SEWAGE DISPOSAL TESTING

PROPERTY OWNER Charles C. Puglisi property

PERCOLATION TEST PLAT CHARLES C. RUGLISI PROPERTY		
SCALE 1"=50'	APPROVED BY:	DRAWN BY: <i>[Signature]</i>
DATE 12-20-71		REVISED:
ORIENTON DAM ROAD 5TH ELEC. DIST. HOWARD CO. MD.		DRAWING NUMBER WG-1022

The Charles C. Puglisi property that is a subdivision and located at Brighton Dam & Haviland Mill Roads has been rejected due to the following reasons:

INDICATE NORTH. - NAME ADJOINING ROADWAY AS BASE LINE
 HAWLAND MILL RO.

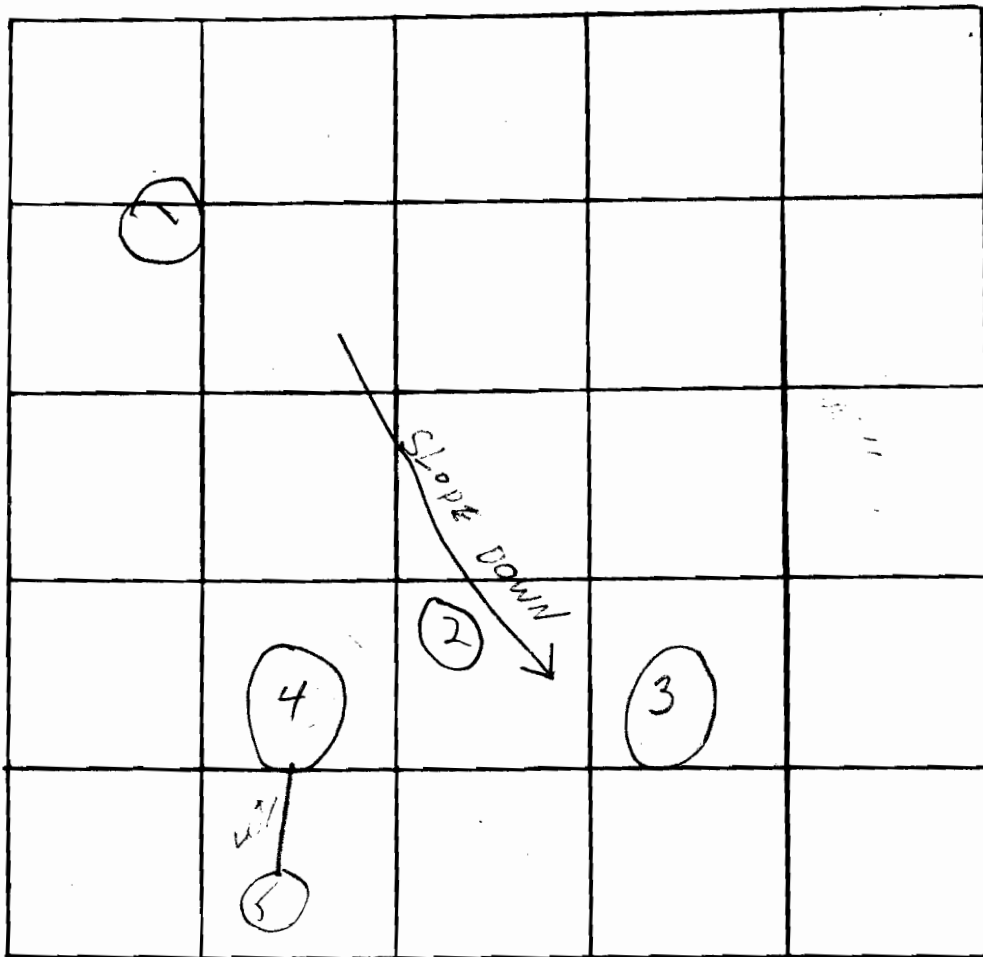
DATE	TEST NO.	DEPTH	PRE-WET		TEST - 1" DROP		TIME
			START	STOP	START	STOP	
	1		NOT	DUG	from north slope		
	1A		- "	"	" "		
	2	12'	VISUAL	SIMILAR TO	3+3A		
			Clay sand-mustard				
	3	12'	235	—	3D NO	MOVEMENT	
	3A	3'	235	237	237	240	3
	4	12'	NO	TEST	wet, rd		
	4A	3'	NO	TEST			
	5	6'	water

REMARKS Centrifuge holes - locations - lot conc. slopes

Lot 4

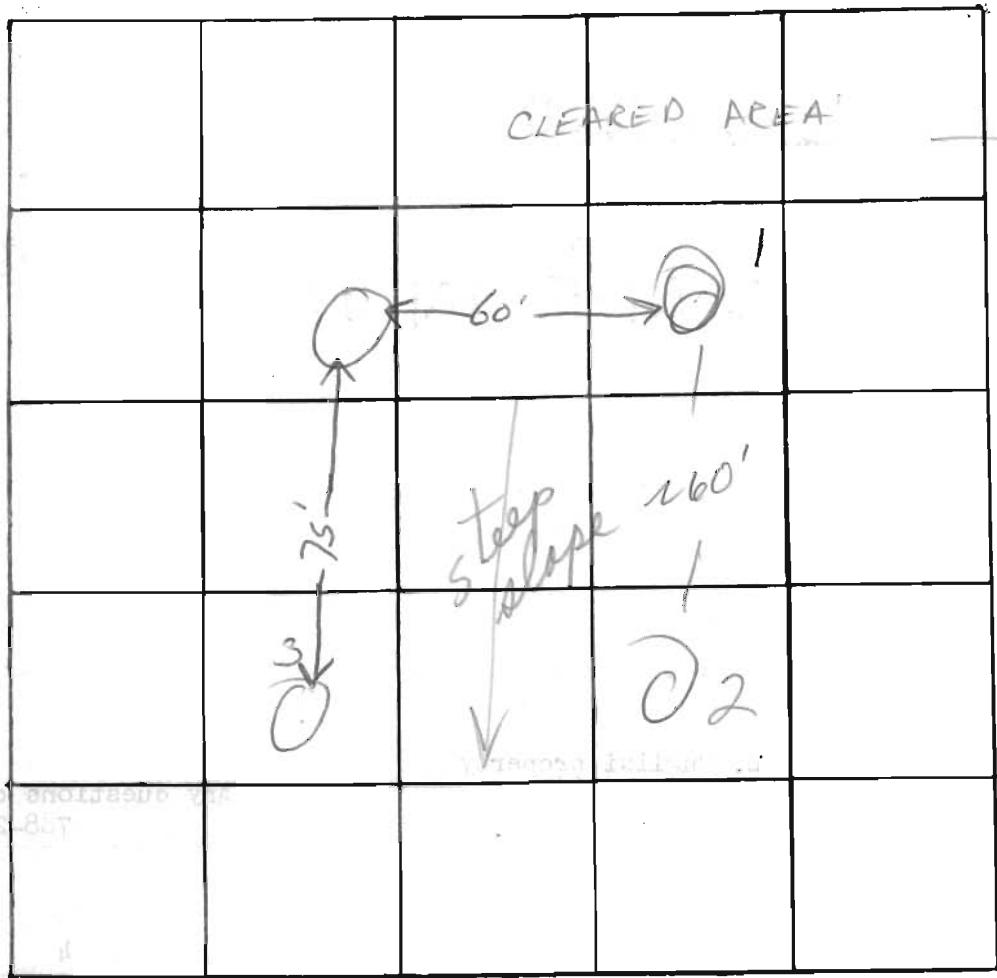
DATE	TEST NO.	DEPTH	PRE-WET		TEST - 1" DROP		TIME	
			START	STOP	START	STOP		
1-9-75	1	11'	1002	1005	1005	1010	5	
	1A	3'	1008	1011	1011	1015	4	
	2	3'	1027	1028	1028	1030	2	
	2A	11'	1022	1026	1026	1050	24	
	3	9 1/2'	1107	1110	1110	1125	15	
	3A	3'	1058	1101	1101	1106	5	
	4	11'	Visual; sandy → rock					
	4A

REMARKS Coring all holes + locations + lot lines + home site - slope

TYPE OF SOIL 1 Sandy Loam 2 Sandstone 3 Rocky sandstone (4)

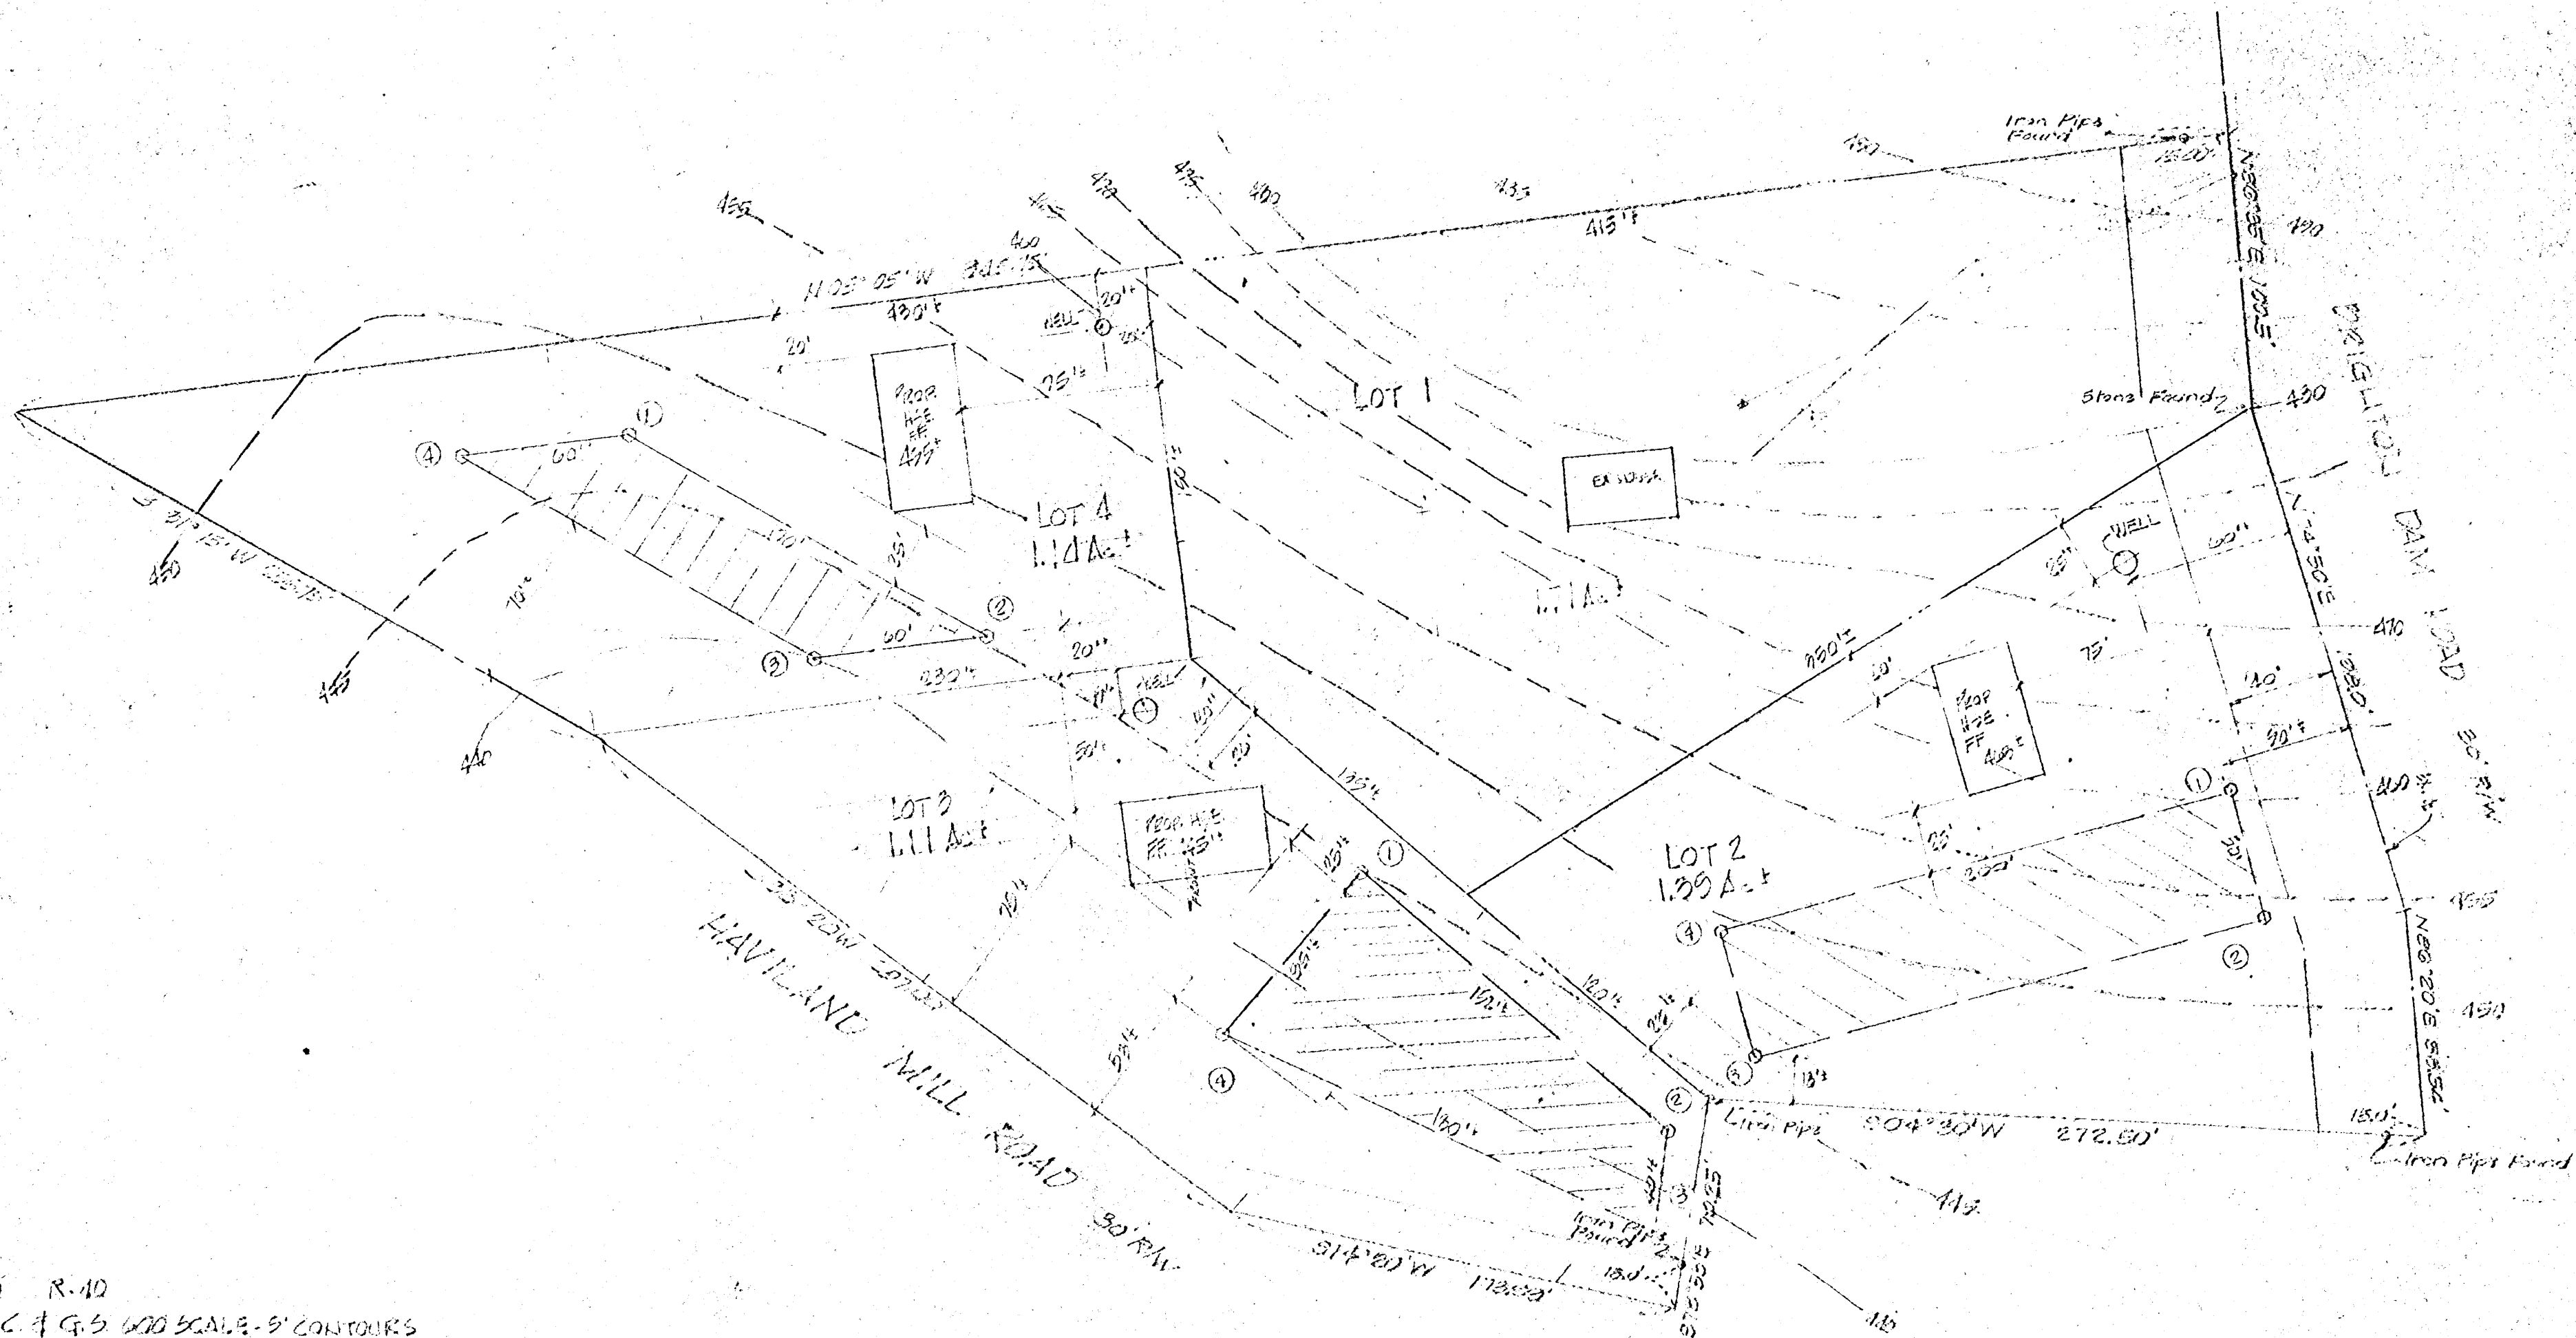
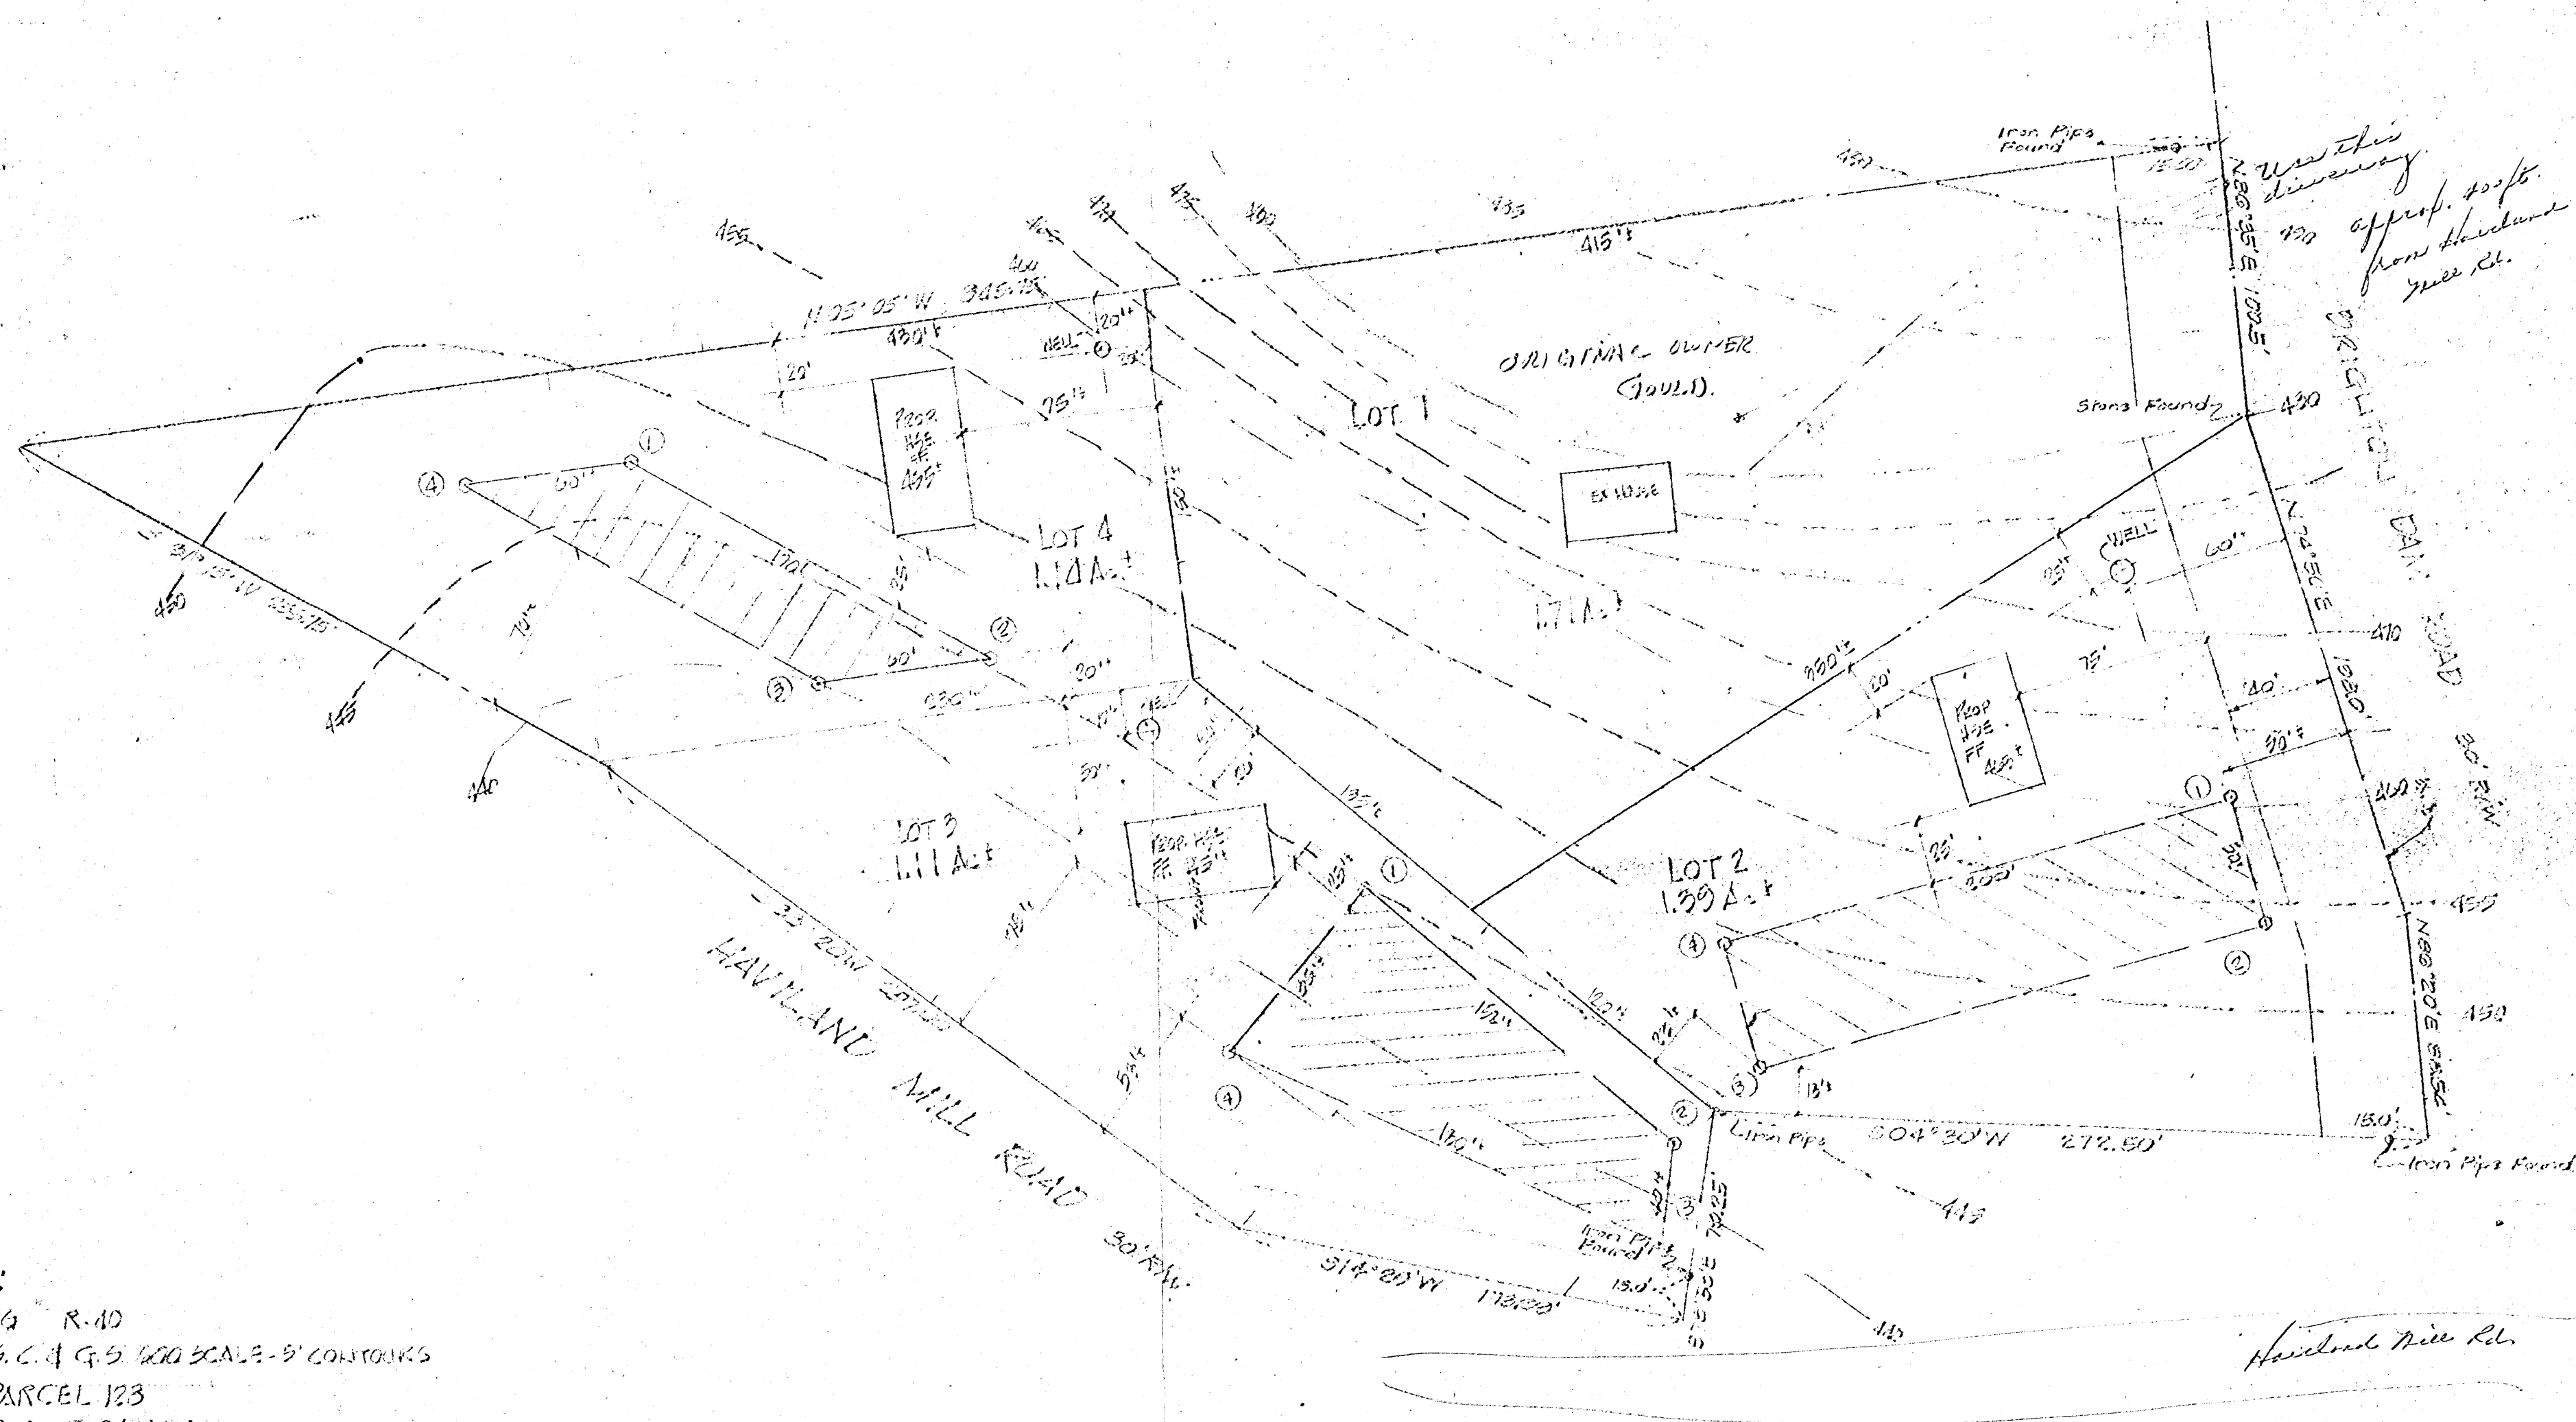
1. Inadequate percolations and high water table on Lot 3.
2. Too steep - slope and ravines (natural erosion) to approve for adequate installation of sewage disposal systems. *This applies to the other lots.*
